REMARKS

Application No. 10/797,565
 NEEDLE AND HUB ASSEMBLY FOR AUTOMATIC INJECTOR
 Attorney Garry J. Tuma (40.210)

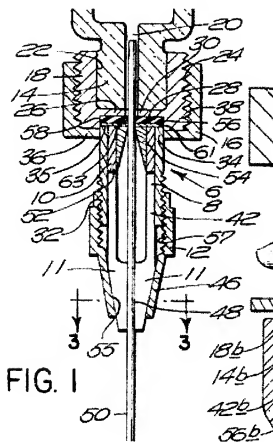
As shown in Myerson's FIG. 1, a portion of which is reproduced and enlarged below for convenience, Myerson's vise 8 and gripping jaws 11 (\approx the first hub assembly) do not extend along the front interior surface of end wall 36. Indeed, the assembly of vise 8, gripping jaws 11, and tube 10 is press fit into aperture 34 in end wall 36 (see column 3, lines 63-66). No part of vise 8, jaws 11, and tube 10 extends along the front interior surface of end wall 36.

Myerson's screw cap 12 (\approx the second hub assembly) does not have reinforcing structures that extend outwardly along and contact the front exterior surface of end wall 36. Indeed, screw cap 12 does not engage end wall 36 at all.

Consequently, Myerson's end wall 36 is not adjoined on the front interior surface by vise 8 and gripping jaws 11 (\approx the first hub assembly) or on the front exterior surface by screw cap 12 (\approx the second hub assembly).
